Project Memorandum

To:	SWCA Environmental Consultants	Doc. No.:	N/A
Attention:	Chris Garrett	cc:	
From:	Amir Karami, Mike Henderson	Date:	July 21, 2020
Subject:	Subsidence Uncertainties at the Proposed Resolution Panel Cave, Response to Malach Consulting LLC.		
Project No.:	1704007

Figure 1. The West Boundary Fault and the lineament identified by Malach from aerial photography and satellite imagery (Malach, March 17, 2019).

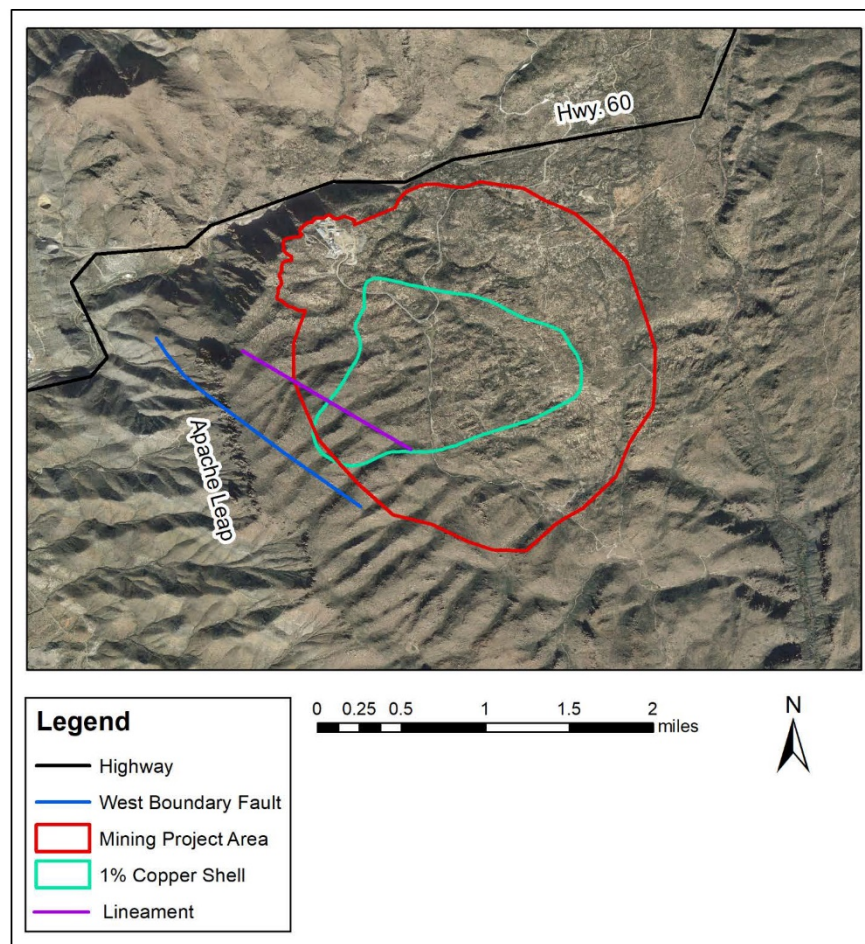
By superposition of the West Boundary Fault on a Google Earth image, Malach identified a pronounced feature (labeled as a lineament) that is subparallel the West Boundary Fault and is offset from the fault by about 2000 ft (610 m) (Figure 1). The lineament is described by Malach as a fracture trace, and not strictly a fault, that is visible from aerial photography or satellite imagery and may represent surface expressions of deep-seated zones of structural weakness such as faults.

Malach stated that *“the nearly-parallel orientations of the West Boundary Fault and the lineament are certainly suggestive that the West Boundary Fault has been incorrectly mapped, and there is no other mapped fault that could be correspond to the lineament”*. Malach further added that *“Unlike the mapped West Boundary Fault, the lineament intersects the caved rock zone, so that there is potential for deformation to be transmitted from caved rock zone to Apache Leap if the lineament is indeed a plane of structural weakness, such as a fault. On that basis, there could have been an underestimation of the extent of the subsidence zone”*.

RCM responded to this comment in a report (RCM, February 26, 2020). RCM compared Malach’s lineament with Resolution’s geologic model wireframe and demonstrated that the lineament identified by Malach corresponds almost exactly with the Gant West Fault previously mapped by Resolution. Figure 2 compares the lineament and Malach’s projected West Boundary Fault (Figure 2, left) with the Resolution’s geologic model superimposed with the 3D model wireframes of Gant West and West Boundary Faults (Figure 2, right).

Figure 3. Flac3D implicit representation of the faults in the region of the Resolution mine footprint (RCM, February 26, 2020).

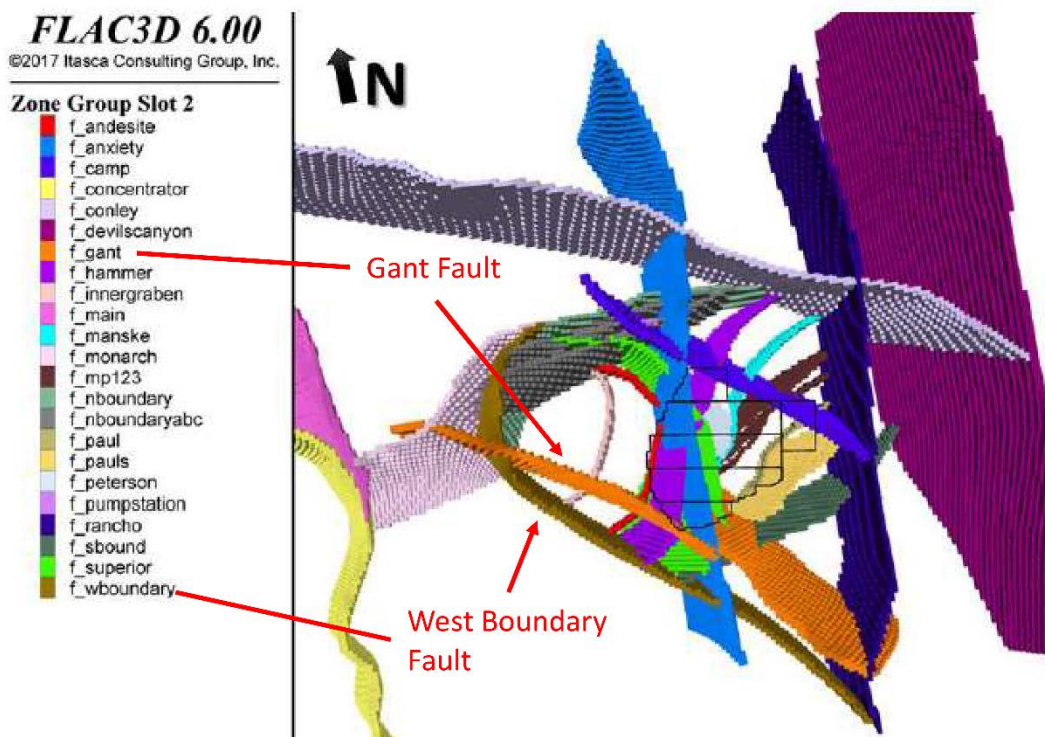
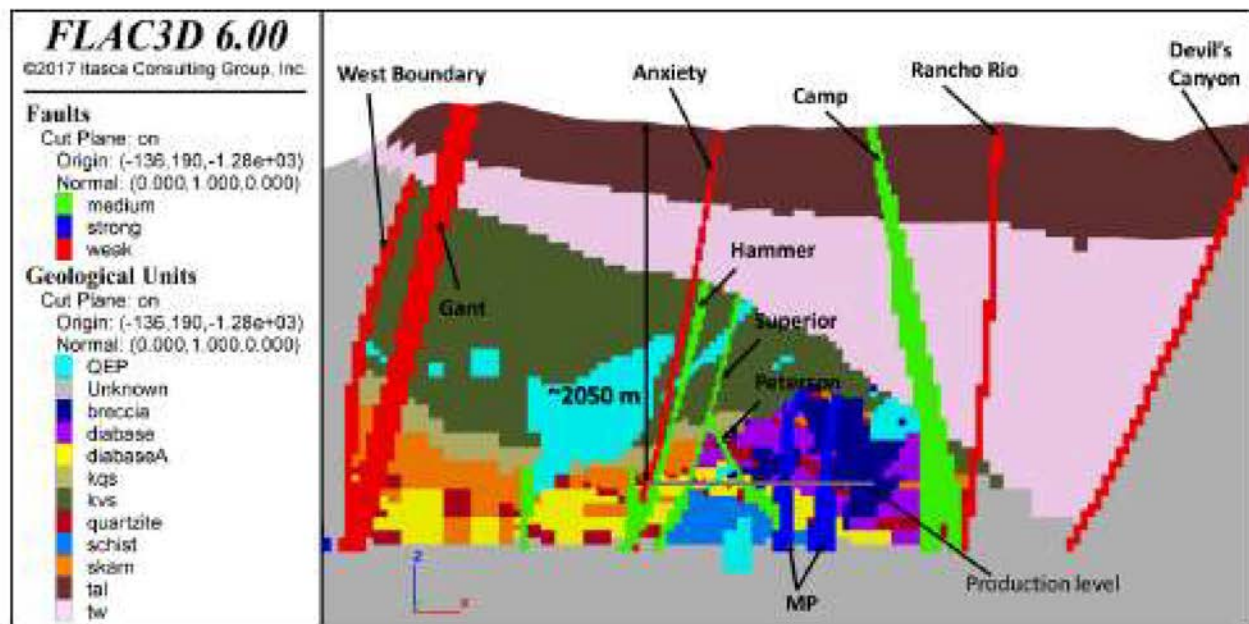
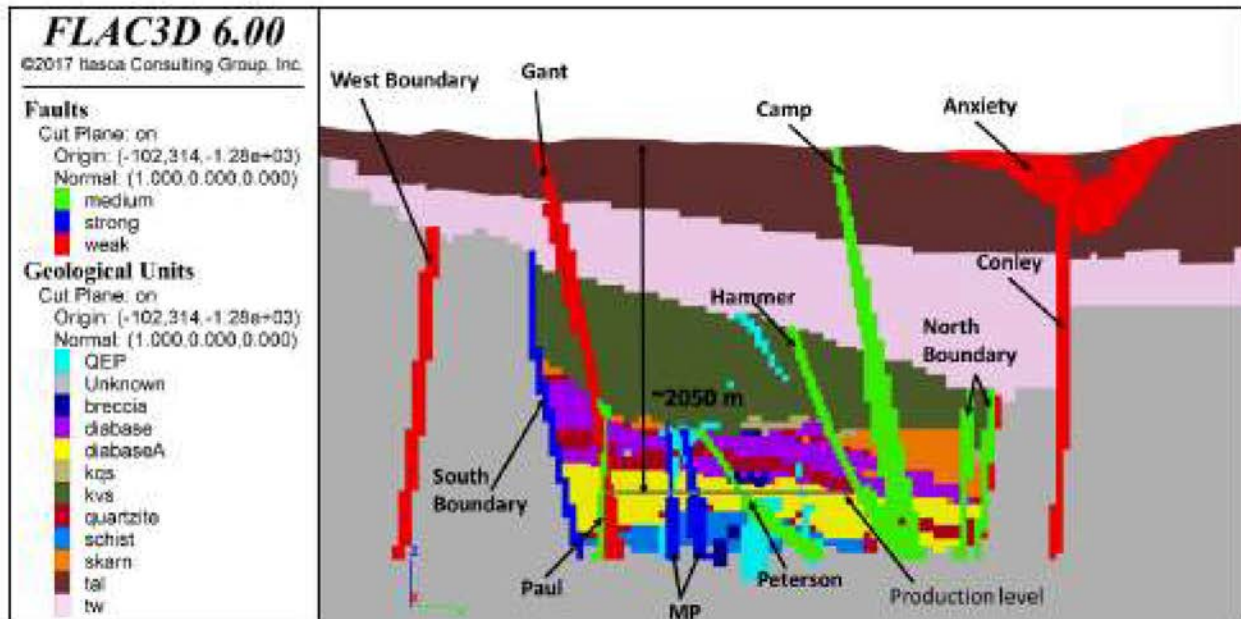
On the question around validity of the subsidence modeling, Malach stated that *“Even if all of the input data were adequate, it would be difficult to assess the validity of the subsidence modeling since no details have been provided, except for the names of the*

consulting companies and their numerical codes. Not even the titles or the lengths of the consulting reports have been provided (GPO, 2014)”.

Itasca also provided a plan view as well as east-west and north-south cross-section plots of the structural model that were implemented in Itasca’s predictive subsidence modeling confirming that the Gant West Fault and West Boundary Fault have been included in the Resolution subsidence modeling (Figure 3, Figure 4 and Figure 5) (Itasca, February 26, 2020).

While details of the subsidence modeling were not provided in the GPO (RCM, September 23, 2014; May 09, 2016), the structural geology model, other geotechnical properties as well as full details on cave modeling methodology were provided in Itasca's subsidence modeling report (Itasca, July 17, 2017). The EIS Geologic and Subsidence Workgroup review of the Itasca modeling report was also available for Malach to review post-DEIS publication.

Figure 6. Resolution Copper planned panel caving sequence.

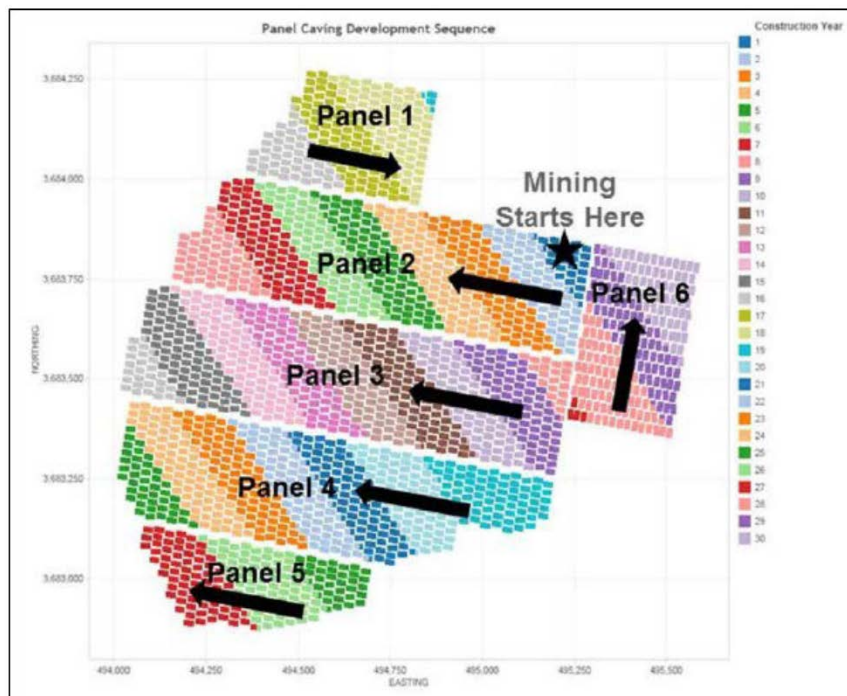
On post-mining monitoring, Malach states “...it is difficult to understand the purpose of the post-mining monitoring, at which point it will no longer be possible to correct the procedures of panel caving mining. This disconnect between observations and subsequent preplanned actions should be regarded as a misuse of the Observational Method, which is used implicitly throughout the General Plan of Operations (RCM, 2014)”. Malach further quoted the Independent Expert Engineering Investigation and Review Panel (2015) that investigated the tailing dam failure at the Mount Polley Mine in British Columbia as stating “The Observational Method ‘uses observed performance from instrumentation data for implementing preplanned design features or actions in response’ and adds that “Observational Method is not simply a license to figure things out later”.

According to GPO (RCM, May 09, 2016), RCM will begin caving at the east end of Panel 2 (Figure 6) which is farthest away from Apache Leap to provide time to monitor cave propagation towards Apache Leap through a combination of aerial, surface and subsurface instrumentation. The RCM monitoring plan includes continuation of monitoring after the end of mining. The post-mining monitoring, RCM states, is to monitor time-dependent compaction of broken material within the crater which will result in residual subsidence or “creep” that can occur over several years (RCM, June 2020). The purpose of the post-mining monitoring is not to be used to correct mine plans in response to ground movements, as Malach suggested, rather it is to monitor the subsidence, any trends and potential impacts on key areas and infrastructure after mining activities have ceased. All remaining functional monitoring instruments used during mining (Phase 3, 4 and 5) will remain active during post-mining monitoring (RCM, June 2020).

RCM's monitoring plan includes a TARP in which an offset is defined based on the distance the actual subsidence boundary exceeds the predicted boundary (Itasca, July 17, 2017) indicating subsidence is laterally progressing closer than predicted to the critical areas (Apache Leap, Highway US-60 or Devil's Canyon). Three trigger levels have been considered in the TARP based the offset distance being i) less than 490 ft (150 m) (Level 1), ii) between 490 ft (150 m) to 820 ft (250 m) (Level 2) and iii) greater than 820 ft (250 m) (Level 3). Each trigger level represents a geotechnical event and is accompanied by a plan of actions to address the changes in ground movements and potential impact on critical areas. RCM plans to determine the measured subsidence boundary based on measured angular distortion which itself is calculated from the ground displacements measured by multiple instruments. For details on RCM subsidence monitoring plan refer to Resolution Subsidence Monitoring and Management Plan (RCM, June 2020).

Figure 7. Comparison of predicted Fractured Zone Limits for base case and all sensitivities (Itasca, February 26, 2020).

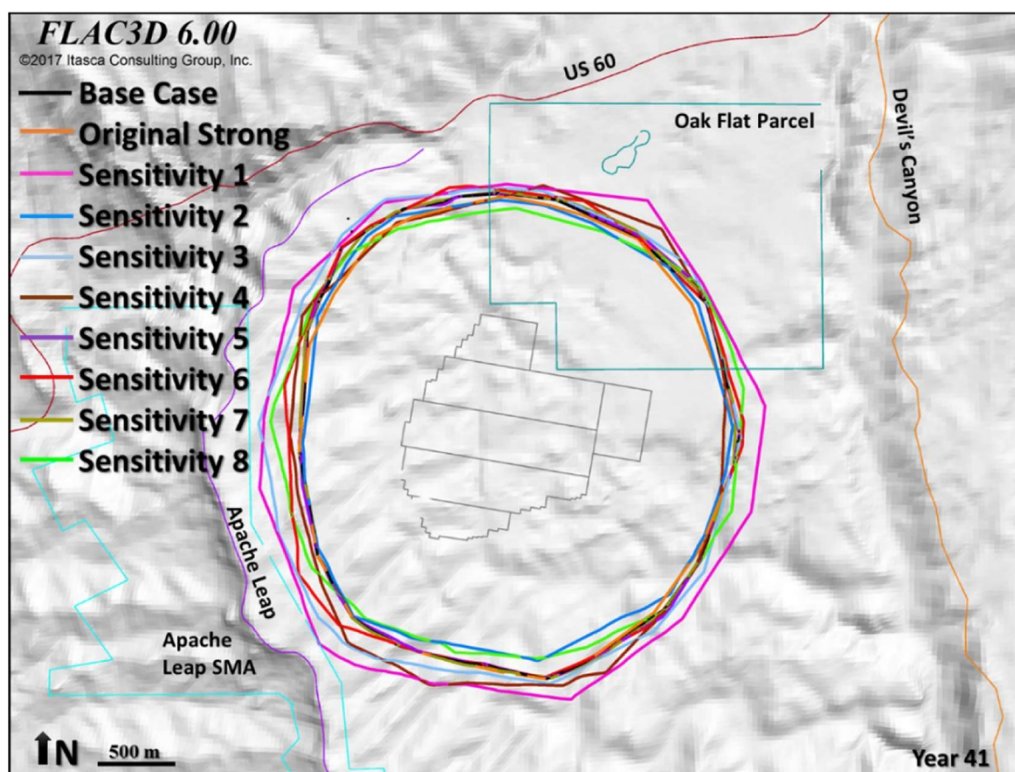
On appropriate error bounds on subsidence predictions, Malach states that *"the predictions of the limits of the caved rock, fractured and continuous subsidence zone contain no uncertainties or error bounds of any kind. Presumably, all predictions are simply the best estimates and not the worst-case scenarios. The only exception to the lack of*

and concluded that the probability of the limit of subsidence reaching the Apache Leap is 5.3%.

Itasca responded to Malach's critique in a memorandum (Itasca, February 26, 2020). Itasca asserted that *"it is completely erroneous to extrapolate from an incorrectly calculated coefficient of variation of the predicted maximum crater depth for calculation of the probability of the extent of surface subsidence"*. Comparing the distance from the predicted base case Fractured Zone Limit to Apache Leap with the same distance between the Fractured Zone Limit of sensitivity cases to Apache Leap along a series of rays that intersect the Apache Leap (Figure 7), Itasca estimated the standard deviation of the distance of Fractured Zone Limit to Apache Leap at 360 ft (110 m). Itasca concluded that for the base case, the minimum distance of Fractured Zone Limit to Apache Leap of 1115 ft (340 m), is more than three times the standard deviation therefore, the probability of Fractured Zone Limit reaching the Apache Leap is less than 0.1%.
